NUREG/CR-XXXX
PNNL-XXXXX

**Ultrasonic Phased Array
Assessment of the Interference
Fit and Leak Path of the
North Anna Unit 2 Control Rod
Drive Mechanism Nozzle 63 with
Destructive Validation**

Office of Nuclear Regulatory Research

Figure 5.8 Brush Used to Remove Surface Bubbles (top); Brushing in Progress (bottom)

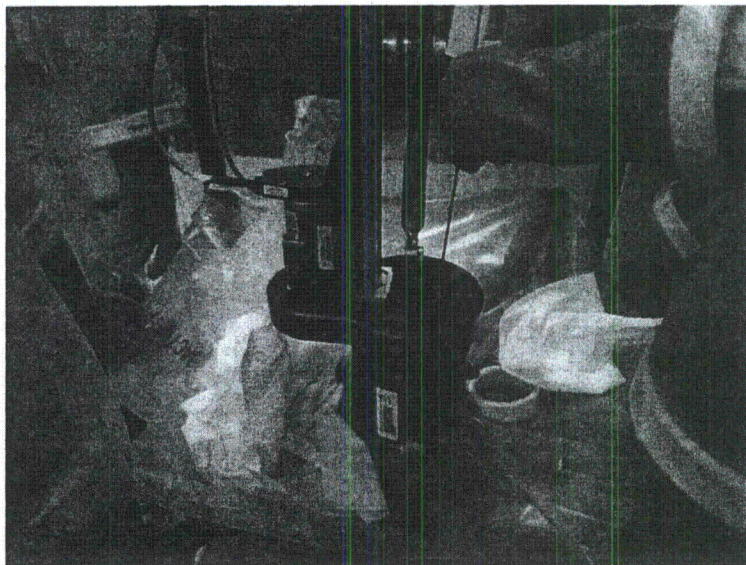
Comment [PG030]: Remove figure.

Figure 5.10 PA Ultrasonic Data from Nozzle 63 Acquired After Second Brushing of the Nozzle ID. The front surface or nozzle ID echo is on the top and the interference fit echo on the bottom. The horizontal axis represents the 86 to 274 degree area and the vertical axis represents 360 mm (14.17 in.).

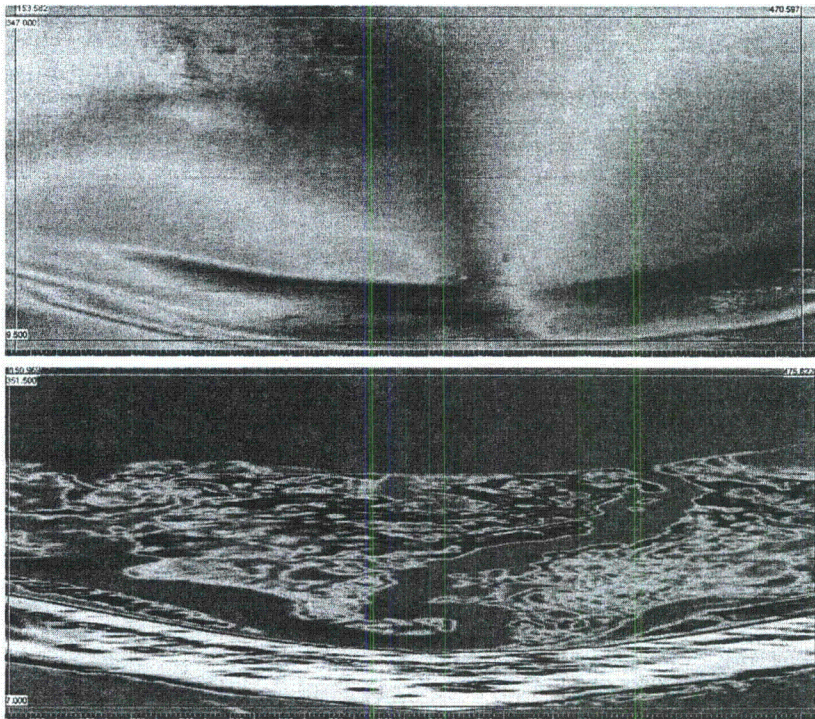
Comment [PG031]: Remove figure.

Figure 5.11 PA Ultrasonic Data from the Interference Fit in Nozzle 63 Acquired After the First Brushing of the Nozzle ID. The horizontal axis represents the full 360-degree area and the vertical axis represents 360 mm (14.17 in.).

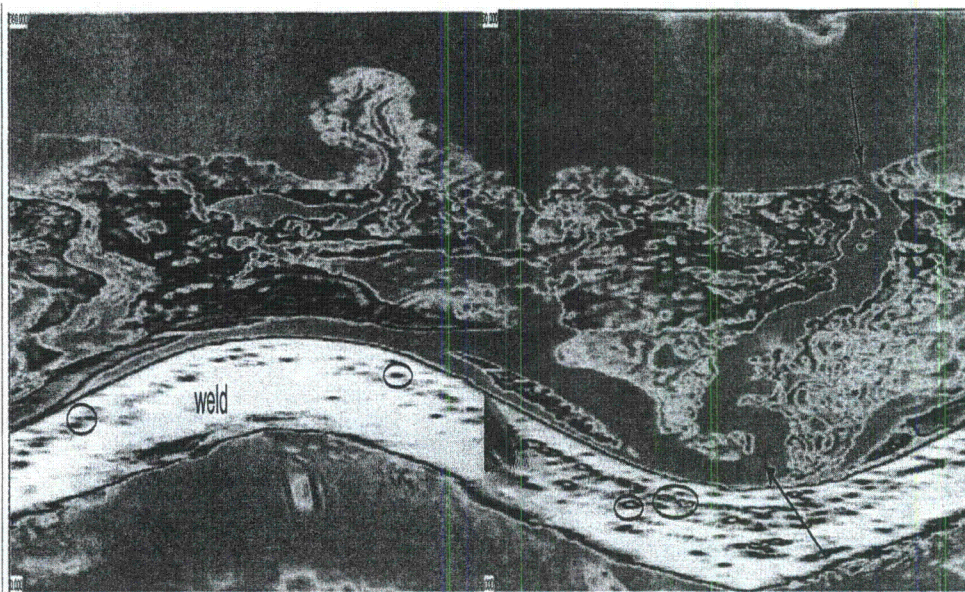
Comment [PGO32]: This is the important figure. Everything in the chapter up to this can be described by a few paragraphs of text at most.

Comment [PGO33]: Say that the arrows indicate the main leakage path. Don't circle the indications. Leave those for the section on the weld analysis. Maybe identify -90 on left and 270 on right for reference.

Figure 5.12 Interference Fit Data Image After First Brushing. The horizontal axis represents approximately 90 to 270 degrees. The vertical axis represents 360 mm (14.17 in.).

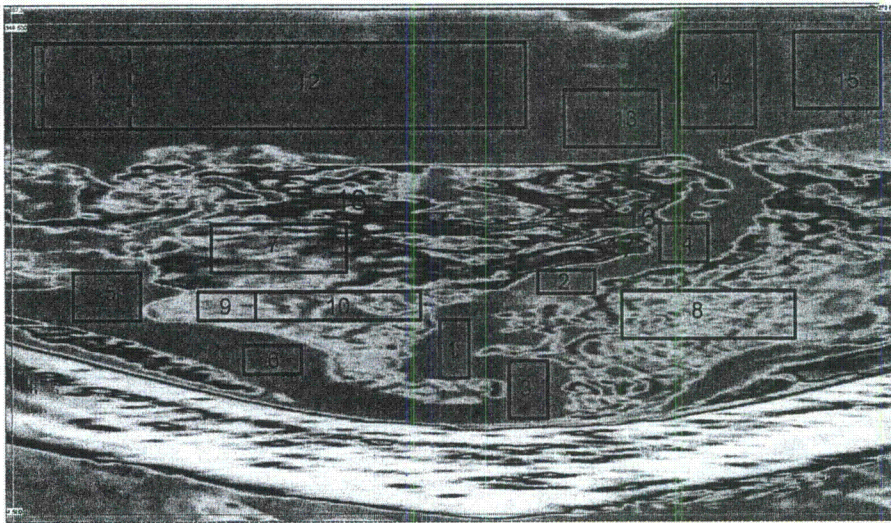
Comment [PGO34]: Make clear that the justification for suggesting that Region 1-6 is leakage path, Region 7-10 is interference fit, etc. is from the mockup results. Say that these suggestions need to be confirmed by destructive analyses.

Comment [PG035]: Say that the boxes correspond to regions for the amplitude analysis.

Figure 5.13 Interference Fit Data Image After First Brushing. The horizontal axis represents approximately -90 to $+90$ degrees. The vertical axis represents 360 mm (14.17 in.).

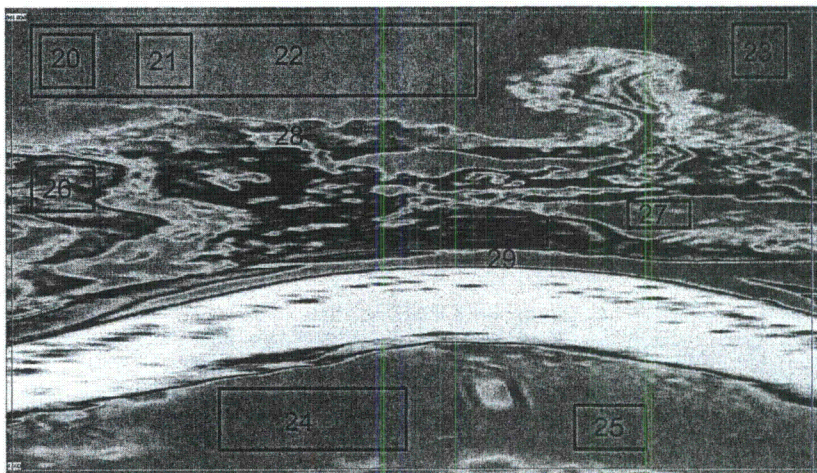
Comment [PG036]: See comment above.

Figure 5.14 Mean Amplitude Response from the Regions Indicated in Figures 5.12 and 5.13

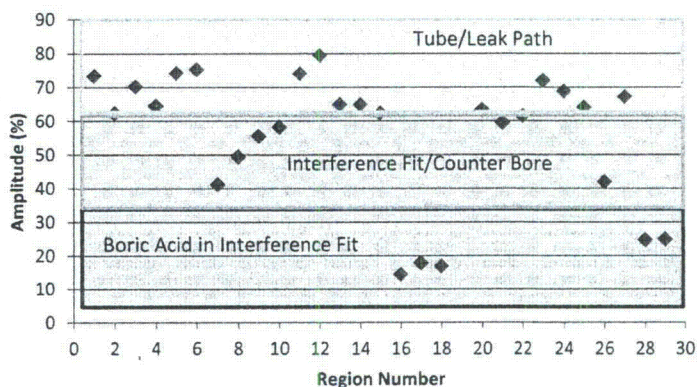
Comment [PG037]: This plot needs to be changed to better display the data. At a glance it looks like a random scatter of points because the region number has no correspondence to the amplitude. For example, it might display better if Regions 1-5 were selected as low amplitude locations, Regions 6-12 were selected as intermediate amplitude, etc.

Figure 5.16 A Tri-Color Representation of the Interference Fit Data

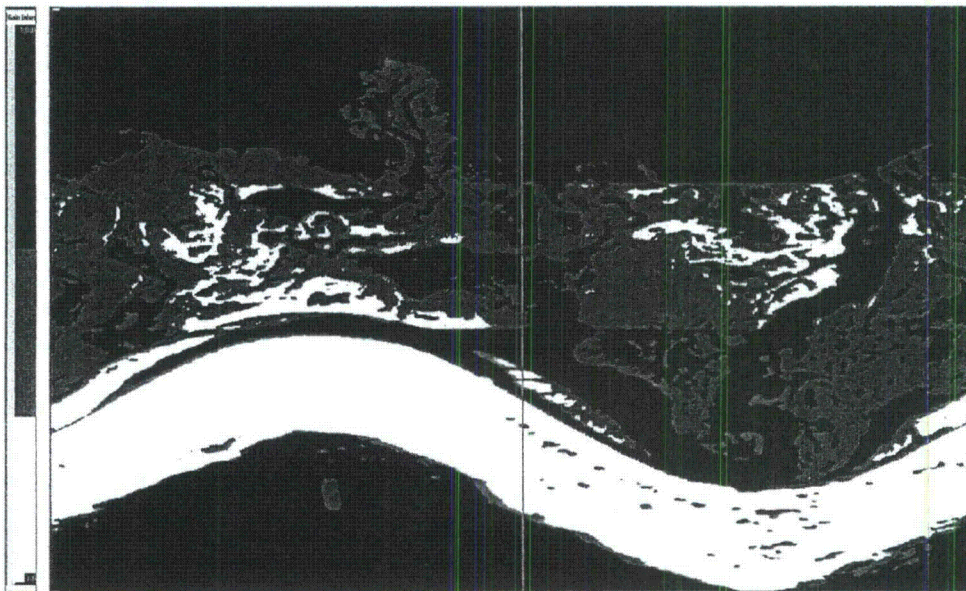
Comment [PG038]: You may state what the 3 colors represent.
